Detailed Site Plan Alternative Compliance Breighton Hills Condominiums

DSP-94052-03
AC-95023-01

SUBJECT: Detailed Site Plan DSP-94052-03
 Alternative Compliance AC-95023-01
 Brighton Hills Condominiums

Figure 1: North Elevation

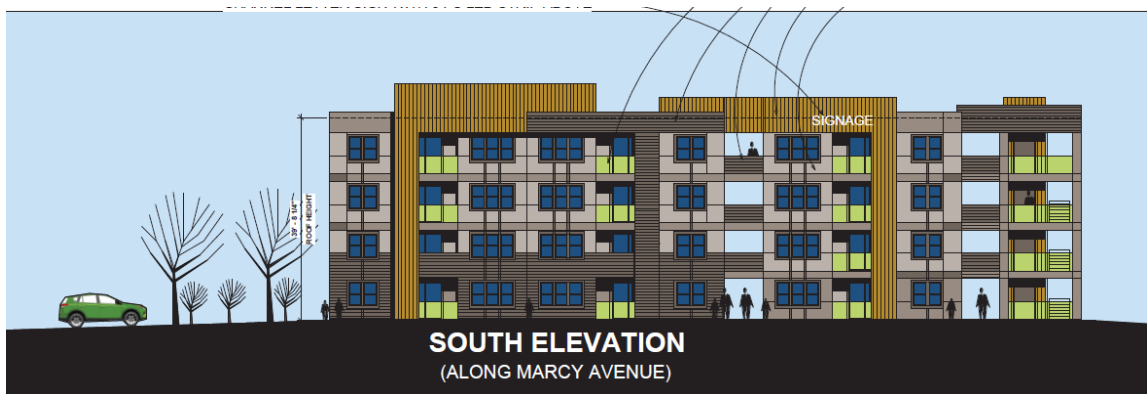
One building-mounted sign is proposed. The aluminum channel letter sign is illuminated and is approximately 8 inches high by 6 feet long. The submitted elevations show the sign on the southern building elevation, but details to fully evaluate the sign have not been provided. A condition has been included herein, requiring the applicant to provide scaled details of the signs and elevation drawings showing its design.

- j. Provide details of the trash enclosure and the building mounted sign, in accordance with prior Section 27-618 of the prior Prince George's County Zoning Ordinance.
